RE: DRAINAGE REPORT FOR PIONEER EAST  
(C-12/D1C) RECEIVED APRIL 2, 1987

APRIL 2, 1987  
REVISIONS TO  
PIONEER EAST  
DRAINAGE  
REPORT

# DRAINAGE REPORT

PIONEER EAST SUBDIVISION

PLATE 3  
OFFSITE AND ONSITE DRAINAGE  
MANAGEMENT PLANS  
RECOMMENDED DRAINAGE IMPROVEMENTS  
AND CONCEPTUAL GRADING PLAN

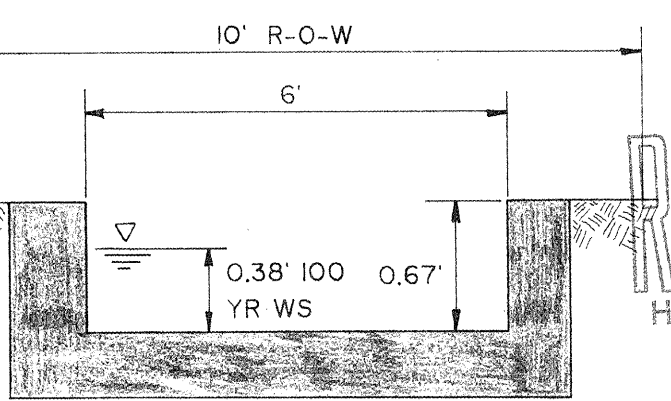
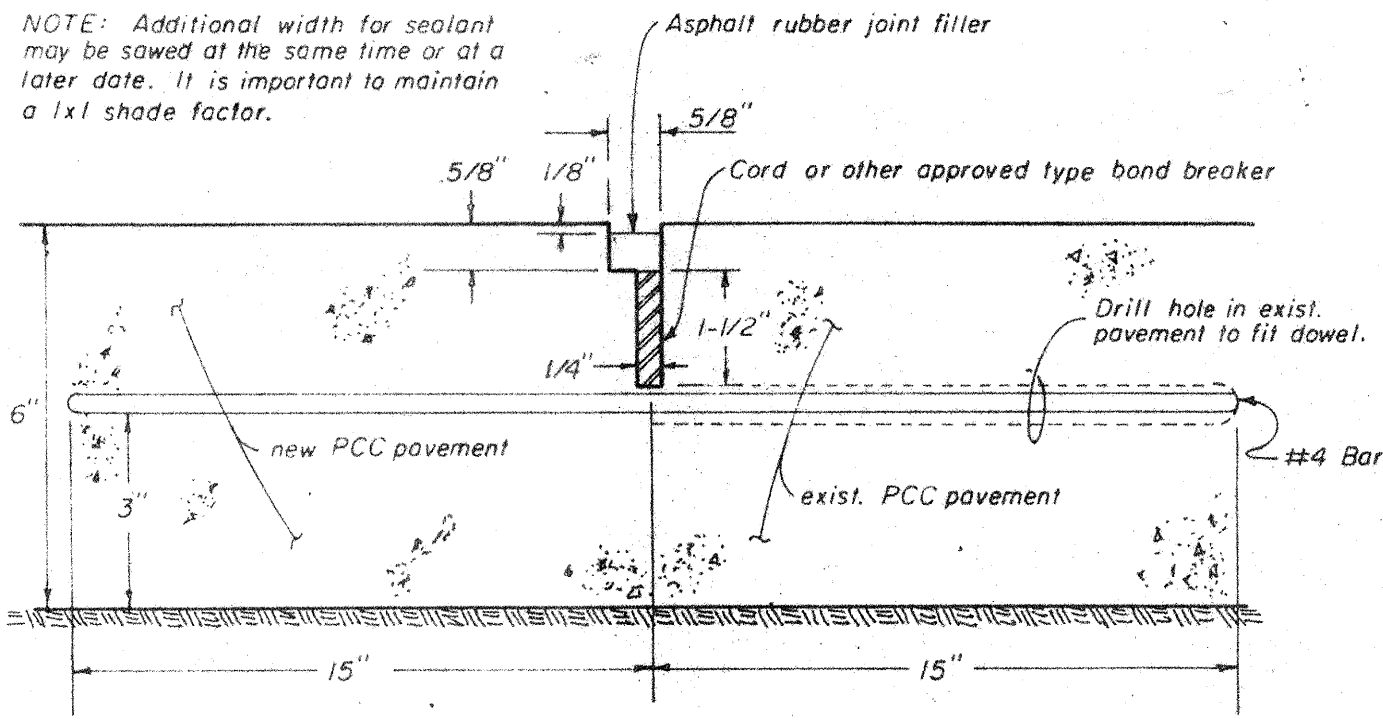
Prior to Final Plat approval, the interim retention pond will need a public easement and drainage covenant. The northeast concrete rundown should be financially guaranteed with this development. The 20 foot easement should be changed to the necessary right-of-way width.
